Product Change Notification

PCN-FDC-7627-2022

| Business Unit | Product Line Code | Type of Change | Action | Date of Issue |
|-------------------------------|-------------------|-----------------------------|-------------------------------|---------------|
| FDC - Field Device Connectors | ABQ | Product Change Notification | Notify Distributors and Field | 1/17/2022 |

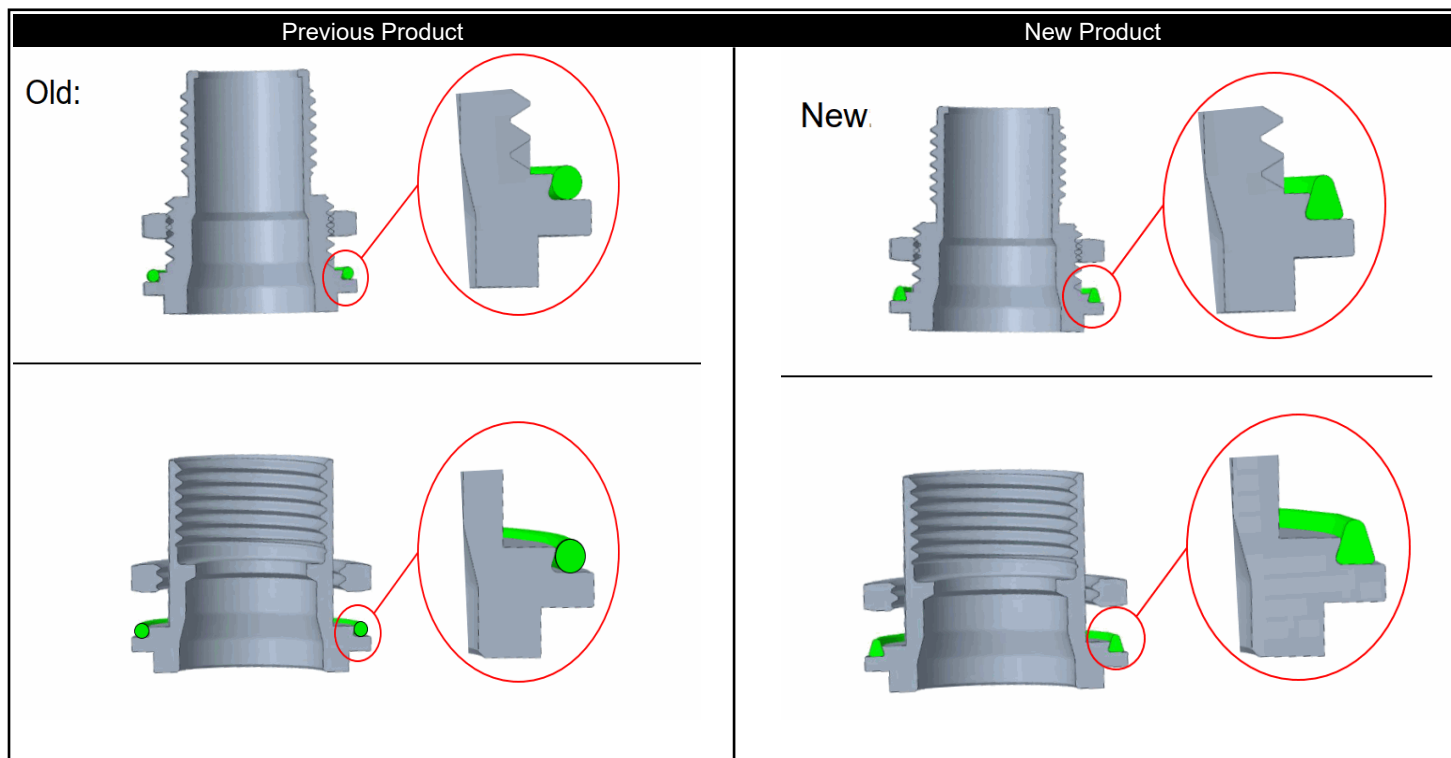
As part of the ongoing improvement process, the geometry of the seal on the housing of the items listed above is being changed. In the future, a molded seal will be used instead of an O-ring. This will allow an even tighter and better fit of the seal. There are no changes to the technical performance data, approvals, or external dimensions. When installed, the housing contour will remain unchanged.
